DESIGN REVIEW RECOMMENDATION

4 1 2 B R O A D W A Y
S e a t t l e , W a s h i n g t o n

DPD Project No.: 3010211
December 2, 2009

RESPONSE TO EARLY DESIGN GUIDANCE RECOMMENDATIONS

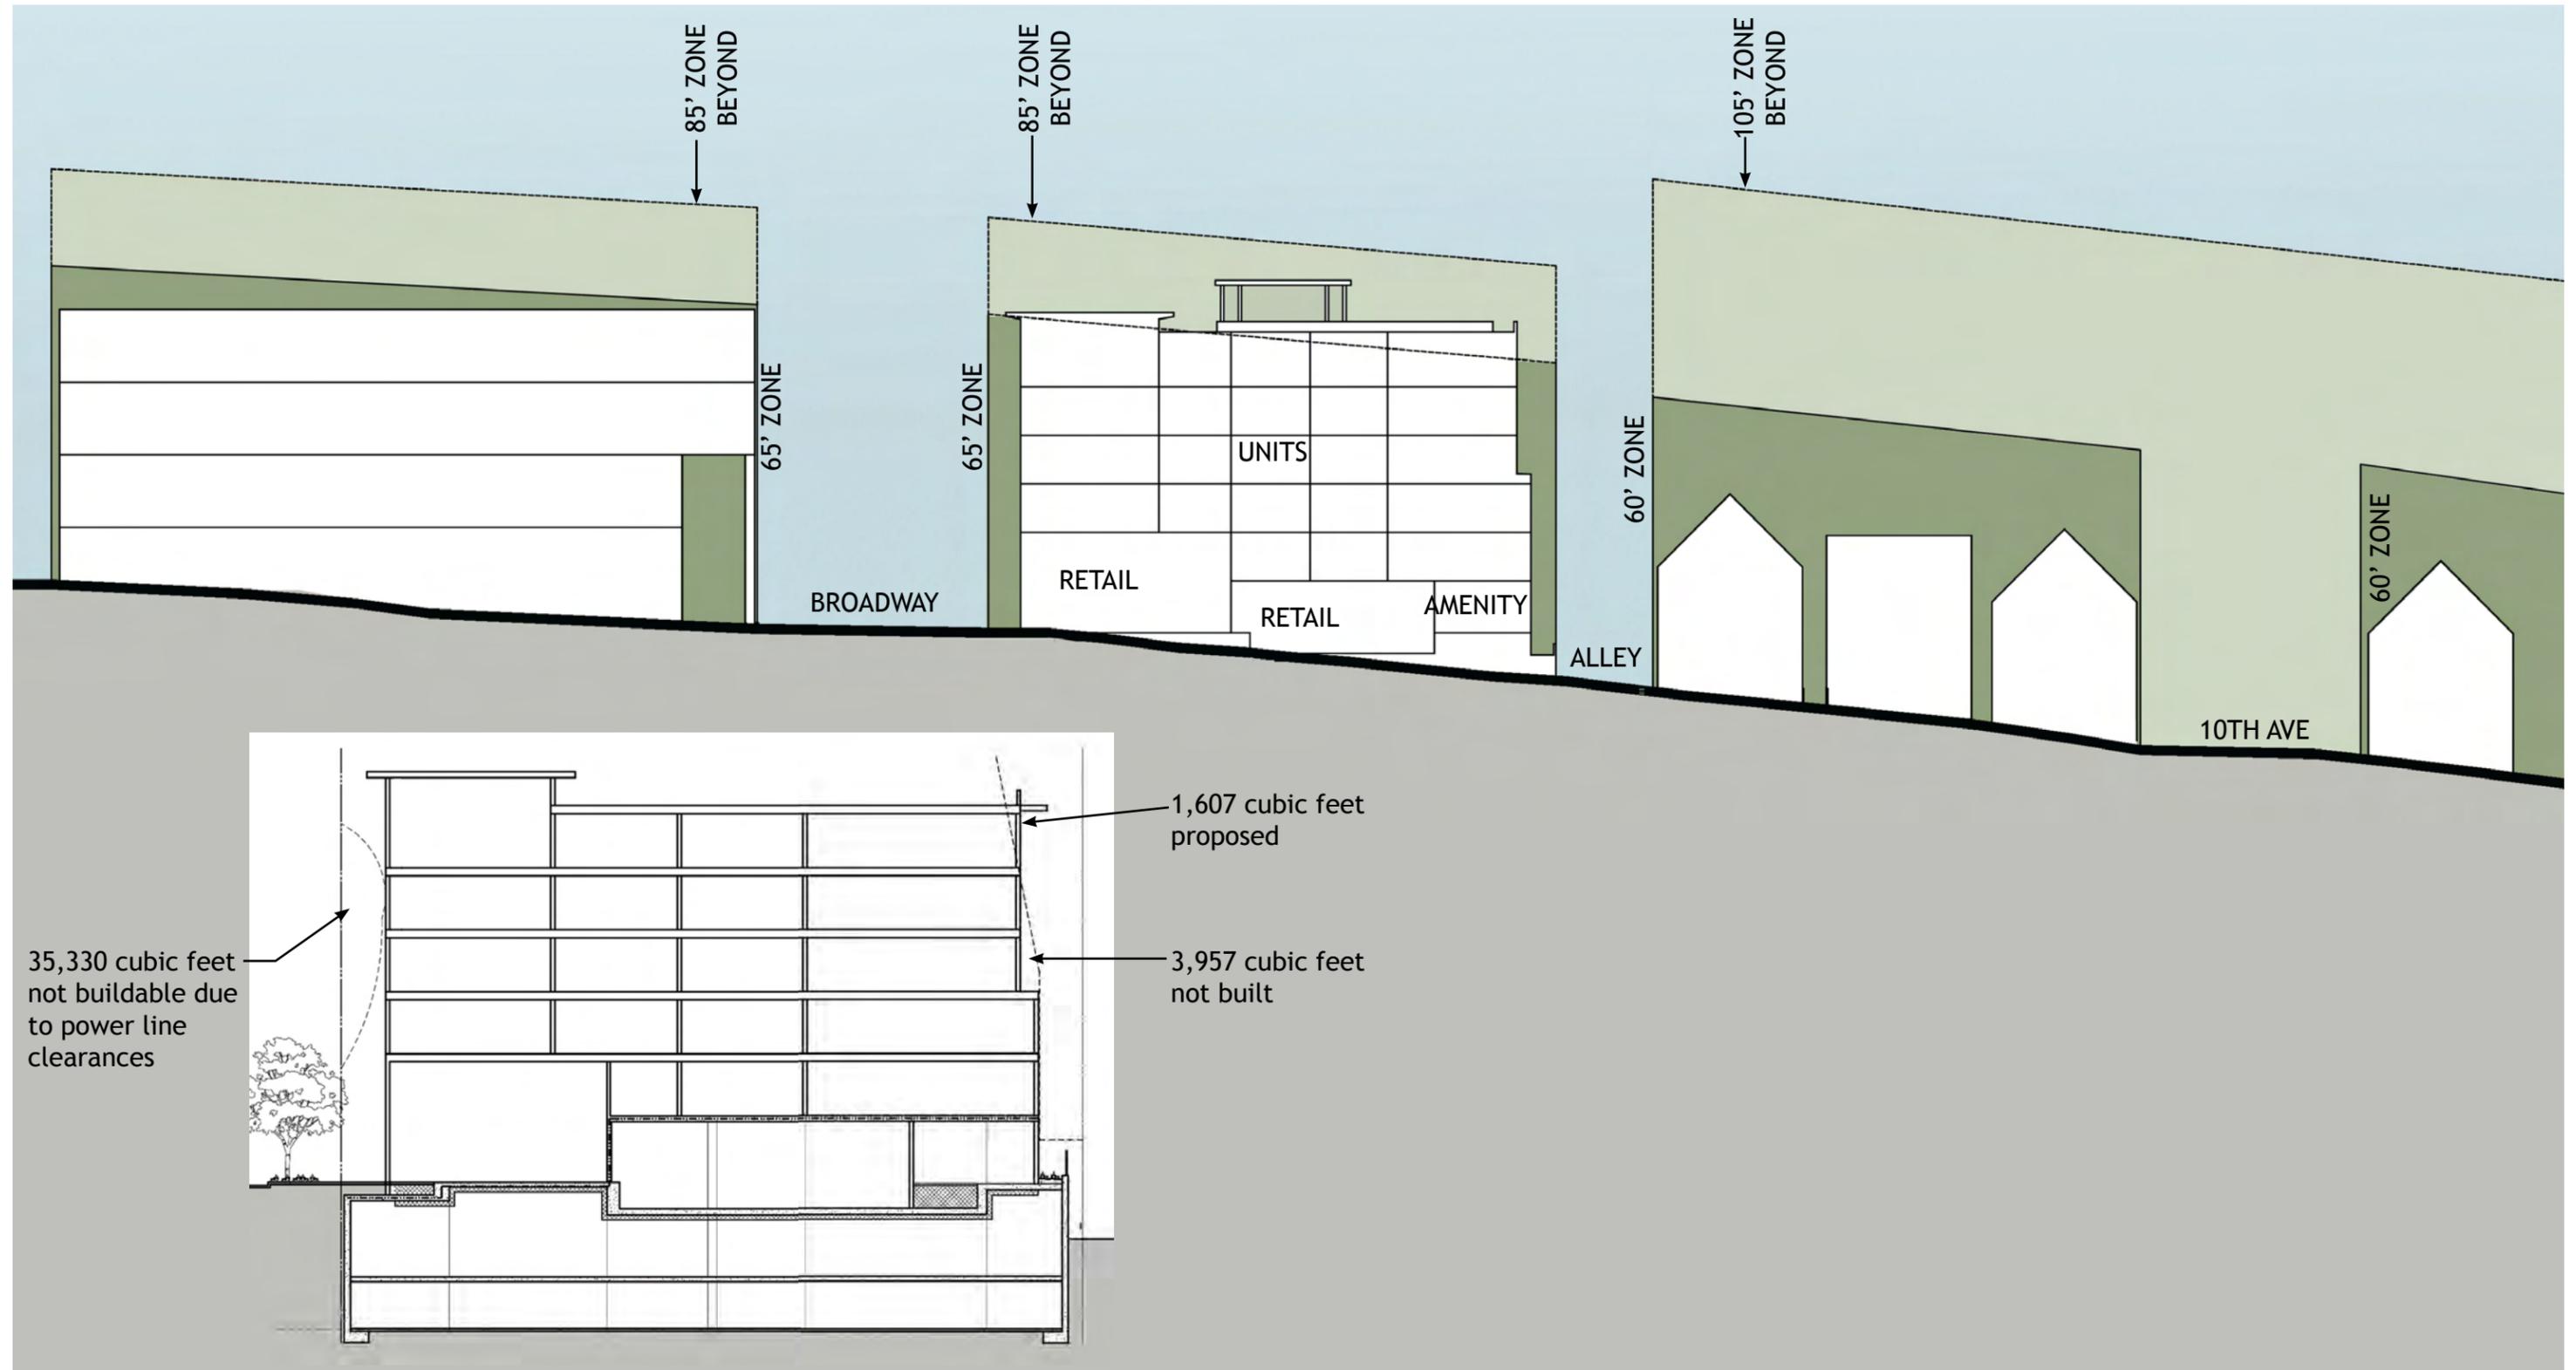
1. C-2, C-4. CHARACTER: CONSISTENTLY USE QUALITY MATERIALS, GROUND THE CORNER

2. A-5, B-1. SCALE TRANSITION: MODULATION SHOULD CREATE TRANSITION TO THE EAST

Proposing brick, large windows, metal siding and cementitious panel rain screen systems on all sides of the building. Brick continues to the parapet at the NW massing element to provide a vertical emphasis and strong corner.

Façade along the alley has 3 setbacks. Alley massing is further articulated by recessing the corner, lowering the parapet, adding larger windows to provide transparency, and using a darker siding color. All of which help the corner massing to recede.

4. SECURITY & TRANSPARENCY

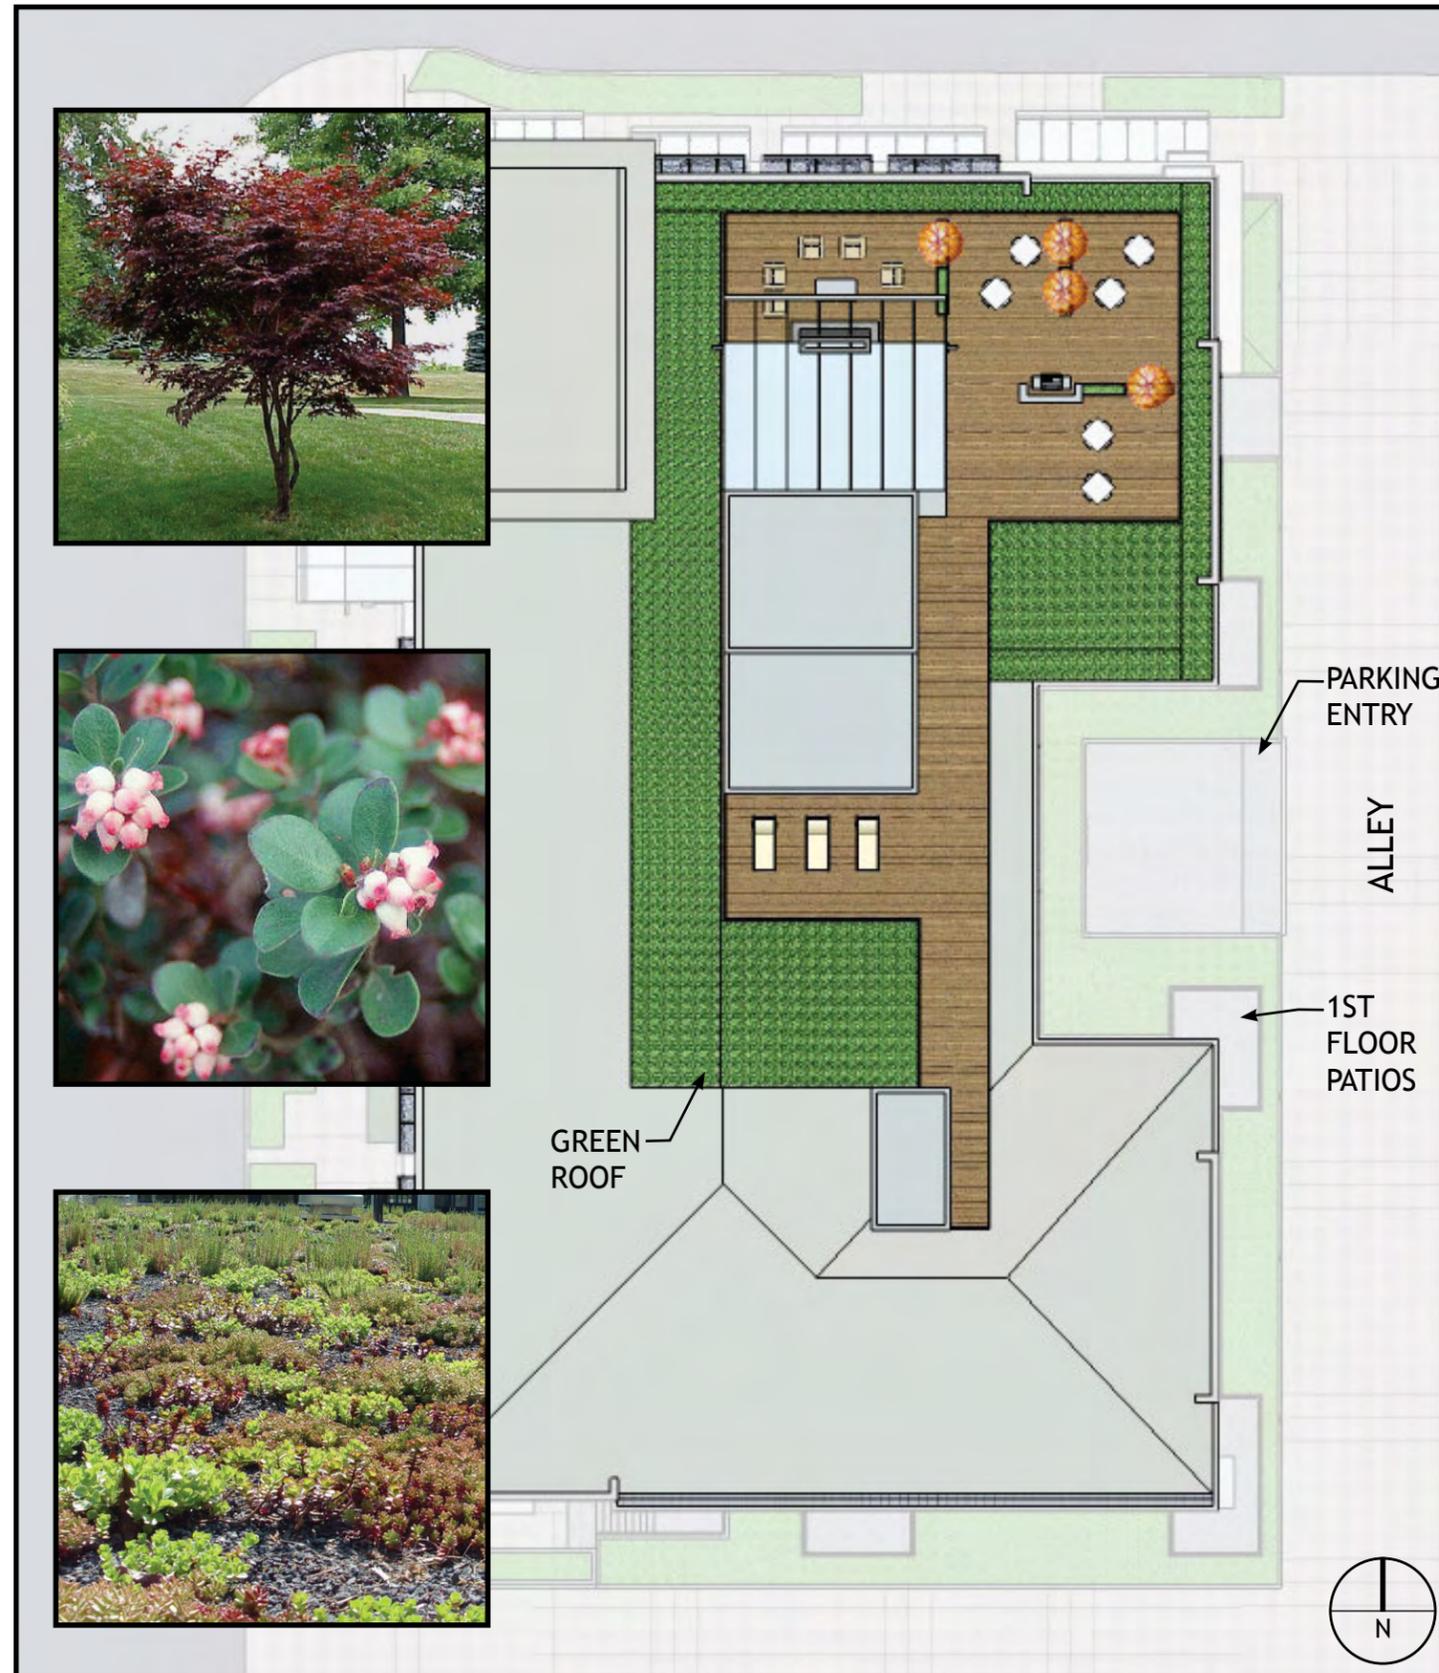
4. D-7, D-11. SECURITY, TRANSPARENCY: STREET AND ALLEY FACADES WELL LIT

Propose to maximize transparency between the brick piers along both streets. Down lighting at the canopies and awnings provide illuminated ground plane. Wall sconces provide lighting at the alley.
